**PETITION FOR TEXT AMENDMENT, MAP TEXT
AMENDMENT, SUBDIVISION APPROVAL, AND SITE
PLAN APPROVAL OF SADDLE RIDGE DEVELOPERS
FOR PROPERTY LOCATED AT SPORT HILL ROAD,
SILVER HILL ROAD, CEDAR HILL ROAD, AND
WESTPORT ROAD (ROUTE 136)**

**Applicant's Supplemental Materials
December 12, 2016**

Re: Easton Crossing Development Technical Review
Final Summary of Findings, Recommendations and Conclusions
GHD File No. 8618269

Figure 1: Bedrock Groundwatershed and Source-Water Area for Easton Crossing Wells

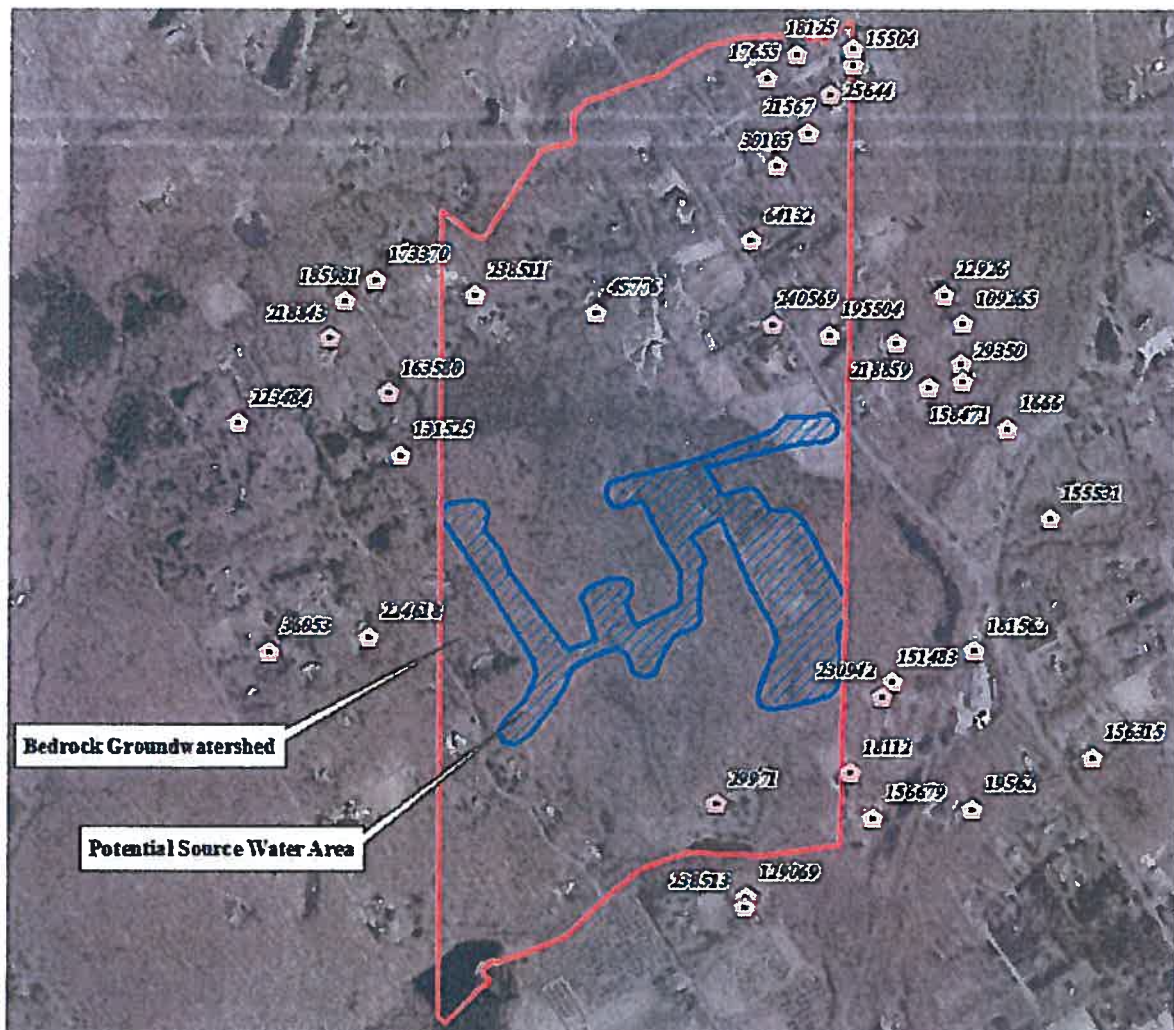
- R1.** Yes, there will be adequate water supply. The Easton Health Department raised this concern when it reviewed Saddle Ridge's 2014 48-lot subdivision plan, and the commission was satisfied by providing the attached report prepared by Scott Bighinatti, Environmental Scientist, and David Murphy, P.E., a hydrogeologist, explaining the quantity of water available compared to the water necessary for each lot and neighbors. Based on our survey of well logs in the vicinity dating back to 1970, the bedrock formation below the site is relatively high yielding.

Based on the USGS mapping, bedrock groundwater beneath the site will tend to flow generally to the north due to the strike and dip of the bedrock. Based on the strike and dip, the bedrock groundwatershed associated with the Easton Crossing site was delineated by using the eastern and western limits of the individual source-water areas (delineated by the blue-hatched area on Figure 1 below) and extending north and south to the nearest watercourses or water bodies (as shown by the red-highlighted area on Figure 1). Although the actual bedrock groundwatershed is likely much larger, extending only to the nearest surface water bodies provides boundaries that are more appropriate for localized analysis of water usage. The total groundwatershed area associated with the Easton Crossing site is approximately 251 acres.

Assuming the bedrock area beneath these 251 acres is recharged at a rate of 7 inches per year (per the USGS³), the recharge of the bedrock will occur at a rate of 90.8 gpm. **The average daily water demand of the Easton Crossing site (21,000 gpd, or 14.58 gpm) is only 16.1 percent of the recharge rate for this bedrock aquifer.**
